Rezoning Transportation Analysis

Petition Number: 2018-100

Date	Description
09-20-18	First Review

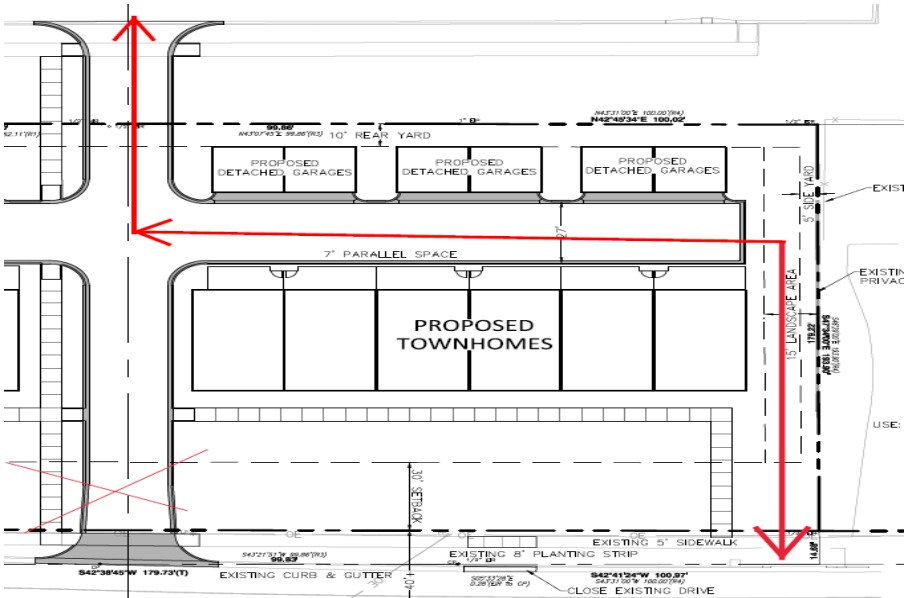
- Curbline** The proposed zoning district has a setback measured from back of the existing or proposed future curbline. The location of the future back of curb for providence is in its existing location. The location of the future back of curb for South Wendover Road is 8' behind the existing back of curb.
- Traffic Study** A Traffic Impact Study is not necessary for the complete review of this petition.
- The petitioner should revise the site plan and conditional note(s) to install 16' planting strip and 6' sidewalk on South Wendover Road and Providence Road.
- The petitioner should revise the site plan and conditional note(s) to relocate the access/street off of South Wendover Road to either of the following scenarios:

a.

b.

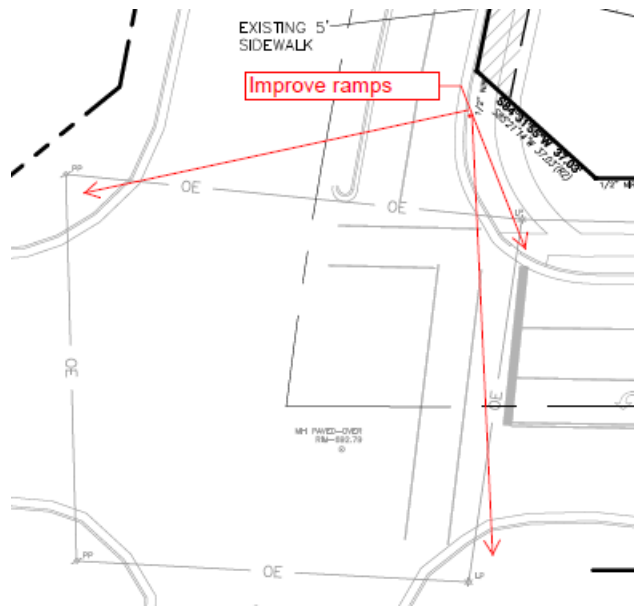
- The petitioner should revise the site plan and conditional note(s) to improve ramps at the intersection as shown below:
